Product Bulletin # **CDS-014** Rev 1

## Use of Proper Insert/Stop Plate Kits

4-1/2" to 10-3/4" Automated Single Joint Elevators Canrig #610091 & #610091-1

Figure 1: Fully Assembled 4-1/2" to 10-3/4" Auto SJ Elevator

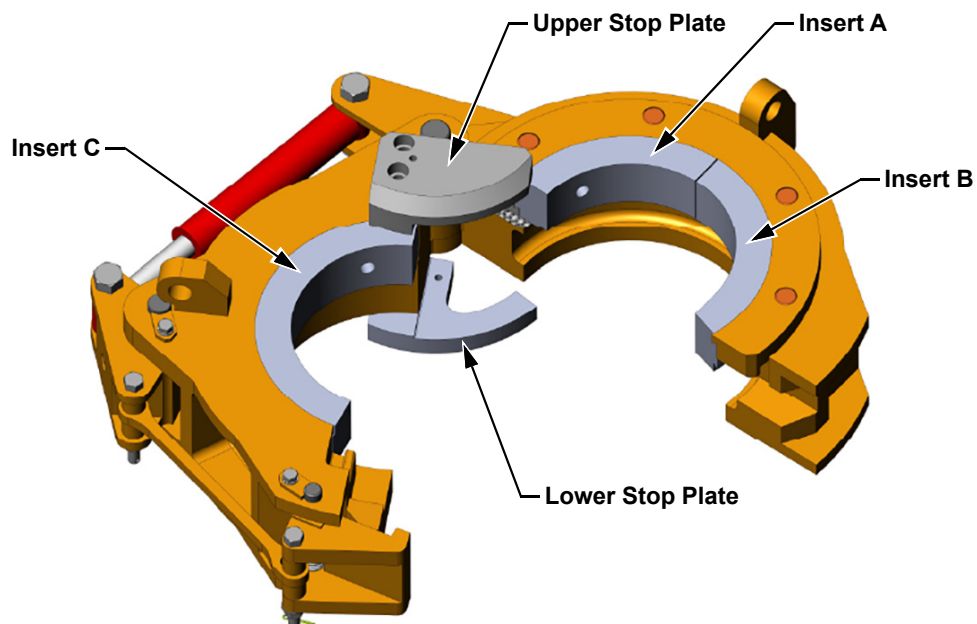
It came to Canrig's attention that premium casing with special coupling OD has been run with existing Insert/Stop Plate Kits, during uncommon set-up and operations conditions. This resulted in one of the two Lower Stop Plate bolts being sheared and a potential dropped object event.

- Use available Insert/Stop Plate Kits for the specified casing size only.
- Always change the inserts together with the Upper and Lower Stop Plates that are included in the same casing size Insert/Stop Plate Kit Bill of Materials (BOM).
- Mixing and matching of various casing size Inserts/Upper Stop Plates/Lower Stop Plates is NOT permitted.
- Contact Canrig for solutions to run Insert/Stop Plate Kits with premium and/or special casing.
